# SERVICE INSTRUCTIONS

0452-359, Rev. II  
ATA Code 24-30

**SUBJECT:** ELECTRICAL (ALTERNATOR) – INSTALLATION OF ALTERNATOR COOLING FAN

**SYNOPSIS OF REVISION:** Deleted alternator fan inspection procedures and installed new vibration resistant fan. Service Instructions rewritten to comply with AD-72-15-2.

Figure 1

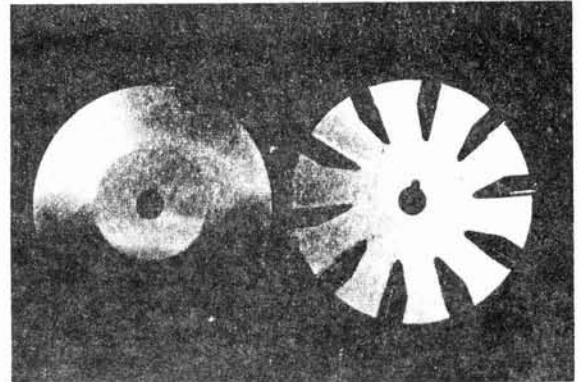
The new, two piece, unwelded construction ventilating fan, shown in Figure 1, consists of a thick gauge aluminum material ventilating fan and a thin gauge aluminum material backing plate. The backing plate is dished to provide vibration dampening when the fan and backing plate are properly assembled on the shaft and the retaining nut is torqued to the proper specification.

Figure 2

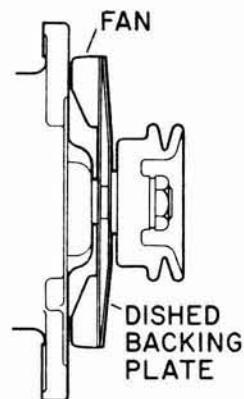
Correct assembly of the fan and backing plate is shown in Figure 2. **Make certain the outside edge of the backing plate contacts the outside edge of the fan.** Install the pulley, lockwasher, and retaining nut then torque the retaining nut to 35 Ft. Lbs. minimum to 40 Ft. Lbs. maximum. Use a strap wrench or a pulley gripping tool, similar to the type shown in Figure 3, to hold the pulley while torquing the retaining nut.
